NOTICE UNDER SECTION 96 (1) CHAPTER IX OF THE BOMBAY
DISTRICT MUNICIPAL ACT III OF 1901 AS MODIFIED
UPTO THE 1st MARCH 1915.Karachi, 28th July 1932.

Pursuant to the provision of Section 96 of the Bombay District Municipal Act III of 1901 I hereby give you notice that I intend with the meaning of that Section to erect a building on plot No. Old/new 33 Survey sheet Old/new R.S. 4 situated in Barnes street Ramsavami Quarter as per Ground plan, Elevation and Section sent herewith in quadruplicate.

Case No. P/C 377 of 1932.

REFERENCE No. B. S. P. 377 OF 1932

— SITE PLAN —
— SCALE 20"=1" —

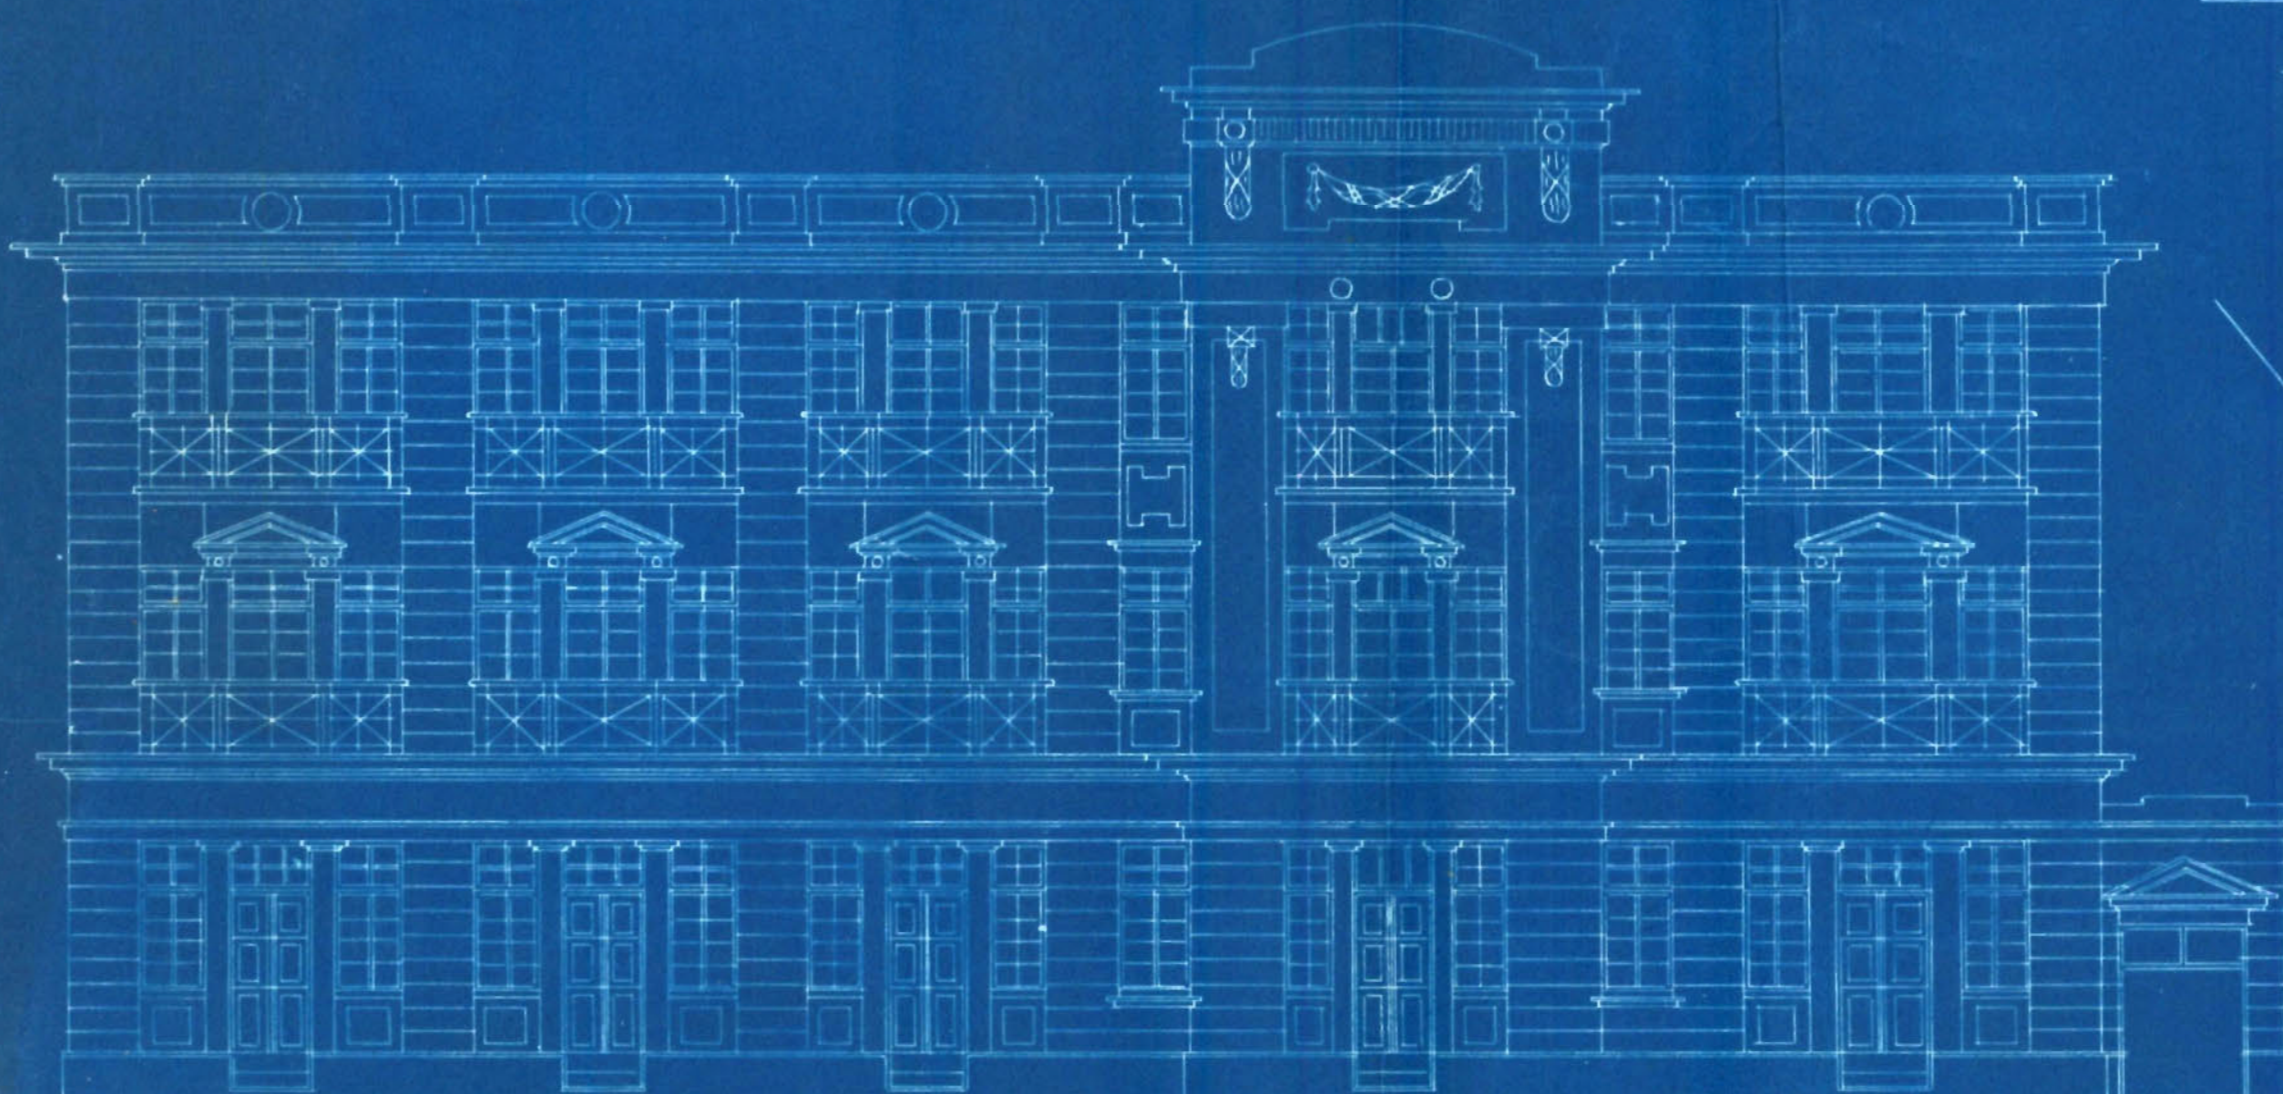
1. $7\frac{1}{2}$ ft Compulsory open line be shown on the plan.
2. Drainage line be shown on the plan.

Calculation for open space.

$$\checkmark 65 \times 7 \frac{1}{2} = 487.5 \checkmark$$

$$\checkmark 50 \times 2 = 100 \checkmark$$

$$\checkmark 30.5 \times 2 = 61 \checkmark$$

$$\checkmark 15 \times 2 = 30 \checkmark$$

$$\checkmark 23 \times 7 = 161 \checkmark$$

$$\begin{array}{r} 9 \overline{) 839.5} \\ \underline{81} \\ 29 \\ \underline{23} \\ 6.5 \end{array} \quad 193.3 \text{ sq yds}$$

ELEVATION

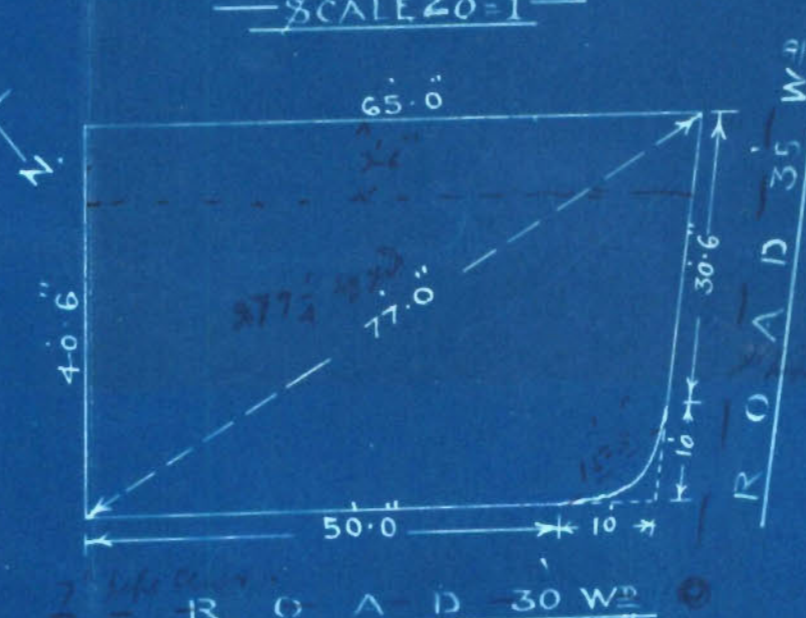
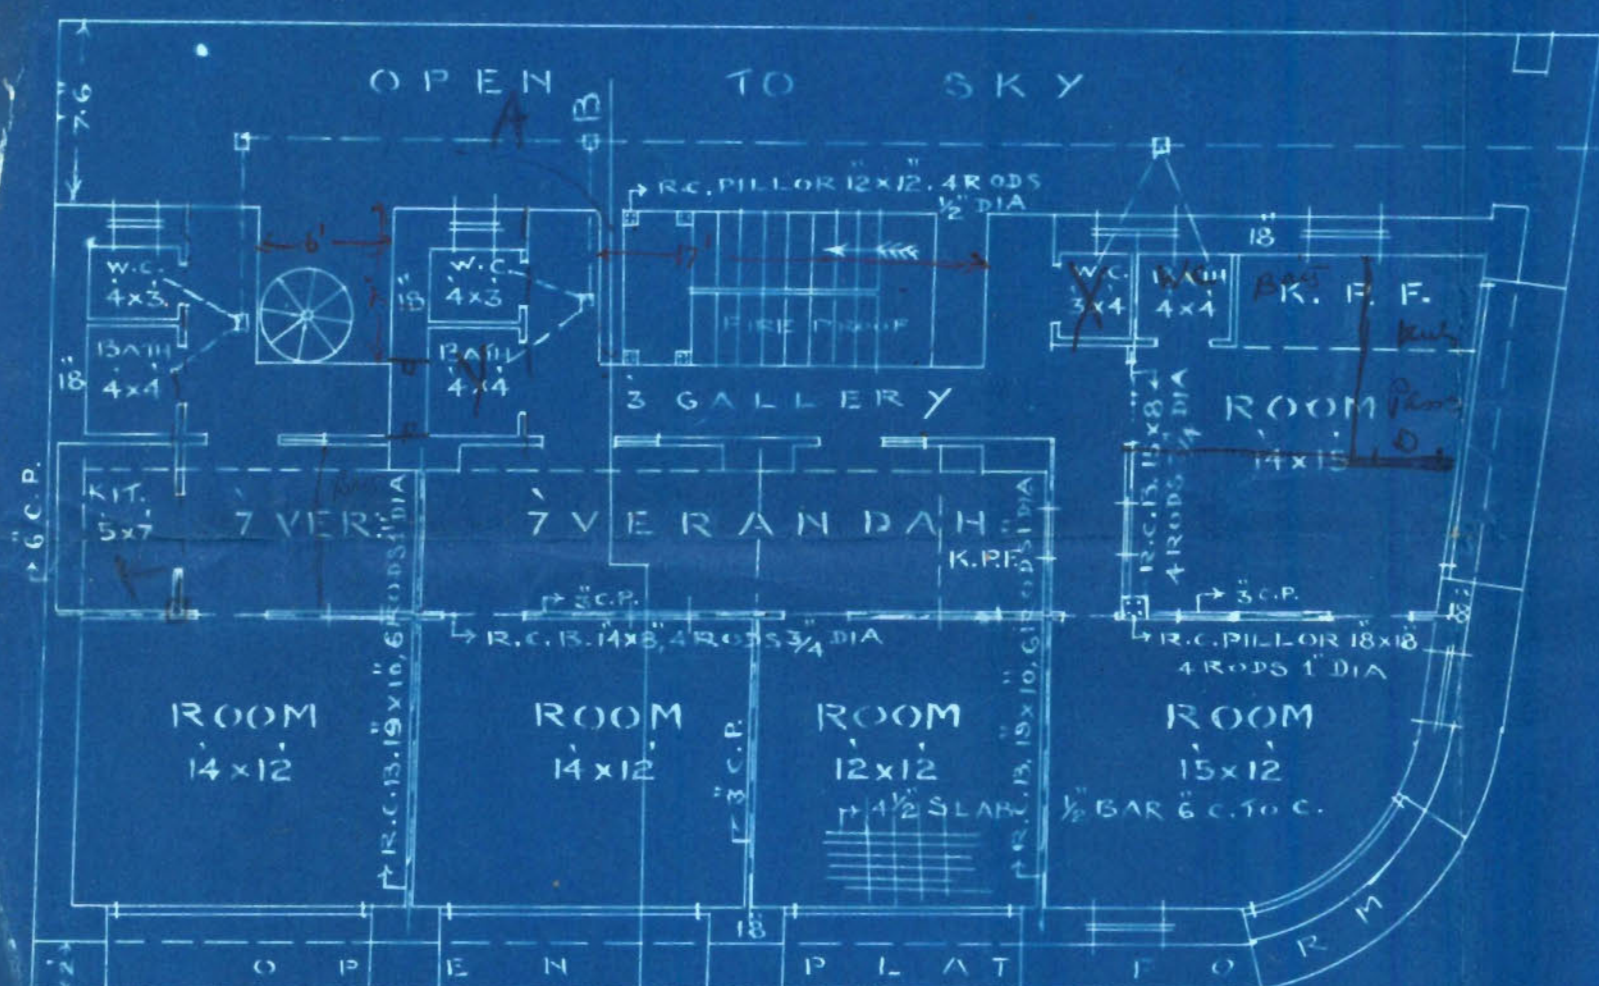
- 1) In the elevation 2 windows & door are shown combined which must be shown in the plan also.
- 2) section of beams, ~~slab~~ ^{rec} stairs, pillars be given as usual.

- 13) Opening in the external wall no front elevation must not be more than half the superficial area.
- 14) General washing place be provided.

- 3) A beam be provided below the sanitary block, as shown in the plan.
- 4) Slab must be $5\frac{1}{2}$ " thick $\frac{1}{2}$ rod 5" c.c.
- 5) Size of front pillars be written down. They must be, an imman load on these pillars be calculated & submitted to the m.e.

- 6) Central partition should be $7\frac{1}{2}$ ' high.
- 7) Compound wall be provided & compound door to open inside.
- 8) Space A between passage in front of sanitary block & the stairs is too narrow & as such the stair case pillars should abut the passage.

- 9) Cross wall must be provided at 30' as the front wall though consist of pillars is 60' long and requires cross support.
- 10) Rec beam 15×8 must have 4 rod 1" diam.

- 11) It must be shown how the 2nd landing of the stairs is supported.
- 12) Kitchen must be platform kitchen like other or it must be solid & barrier above.

B.S. & d.s. of the staircase can't be considered as open, circular staircase can be allowed for purpose of access to the building. P. ask the architect to design in accordance with some of the designs of Panness Street Plot? W.C. opening to staircase is not desirable. Open space indicated on the Site plan in the area of plot + area behind the building. The platform dimensions at the staircase must be calculated & if it is proper corrections are made on the plan. 3/10/8/32

—GROUND 1ST & 2ND FLOOR PLAN—

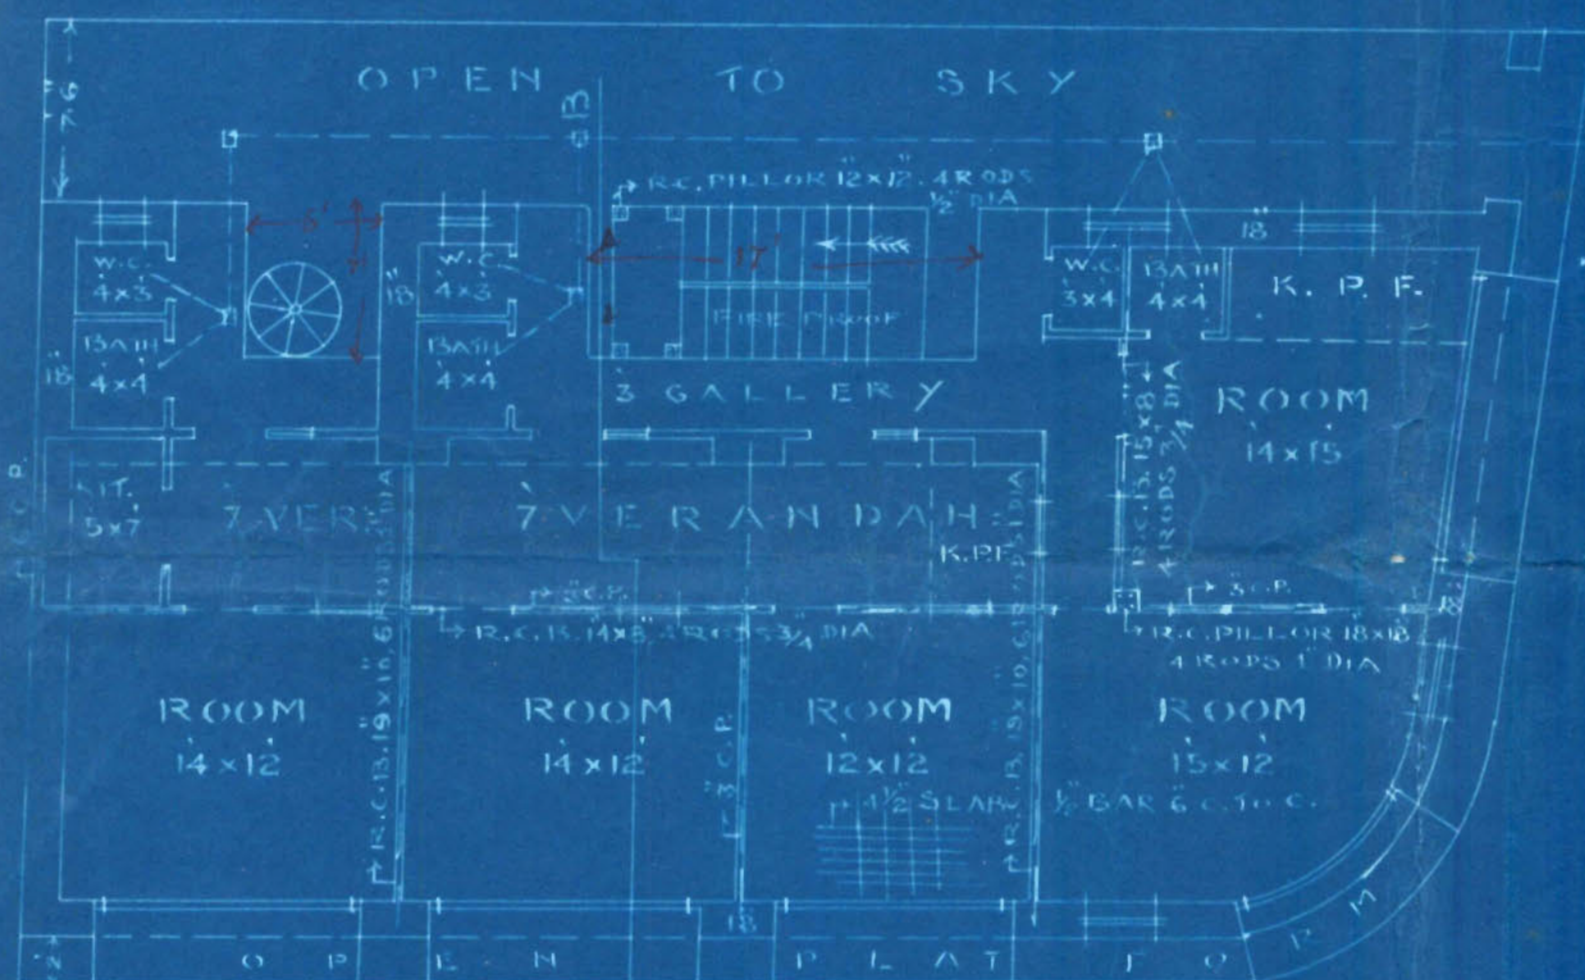
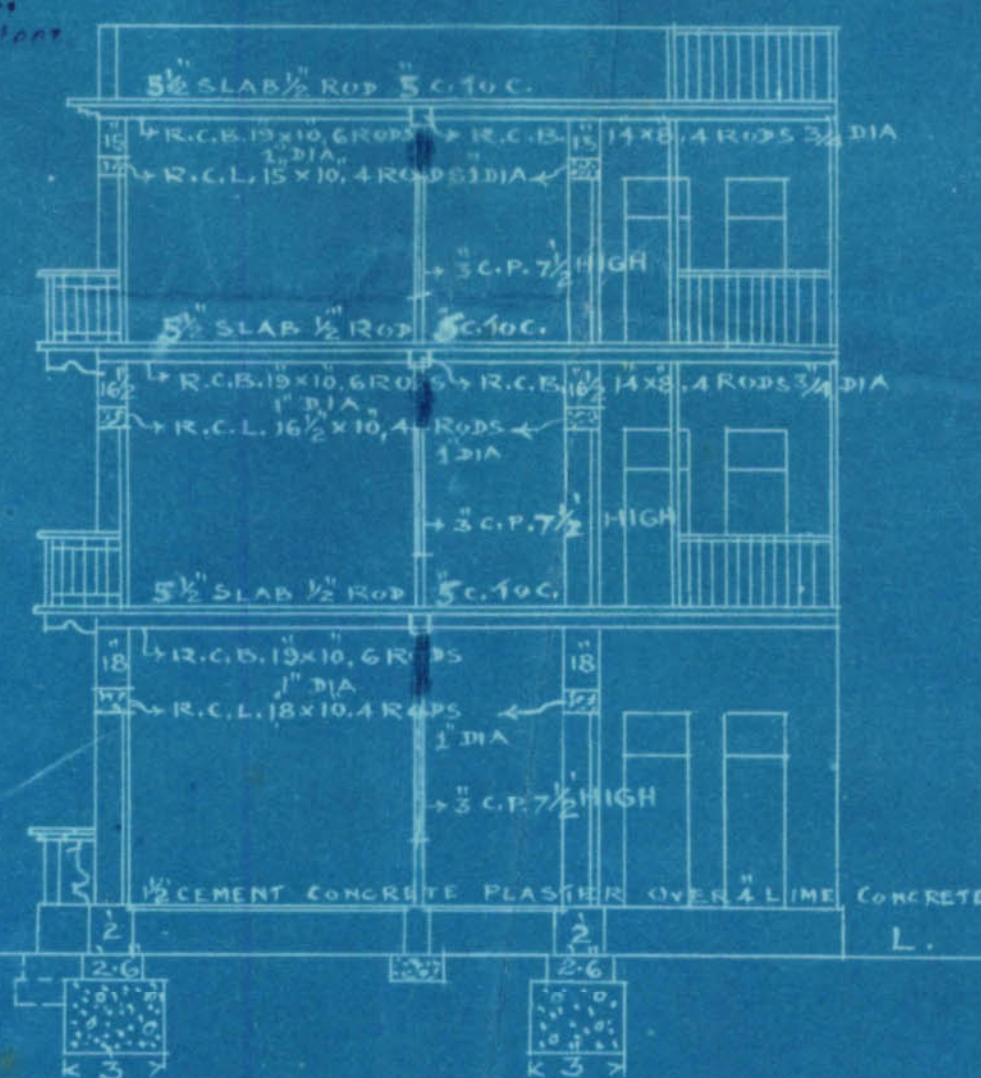
- (1) ✓ Openings in the front elevation must not be more than half the superficial area.
- (2) ✓ General washing place be provided.
- (3) ✓ 7 1/2' Compulsory open line be shown on the plan.
- (4) ✓ Drainage line be shown on the plan.
- (5) ✓ Staircase can't be considered as open.
- (6) ✓ Circular staircase can't be allowed for purposes of the only access to the building.
- (7) ✓ The architect must design in accordance with some of the designs of Princess Street plots.
- (8) ✓ No opening into the staircase is not desirable.
- (9) ✓ Open spaces must be dimensioned on the site plan with the area of floor same proposed to be built upon.
- (10) ✓ Open platform must be omitted. The staircase must be constructed at right angles to its position.
- (11)
- (12)

design is altered now

Fire proof curtain wall 6' high is proposed with little open left between base of front & the stair case landing

Submitted, the architect has complied with all the objections except no (1) and (2) res. R. orders if plans can be approved.
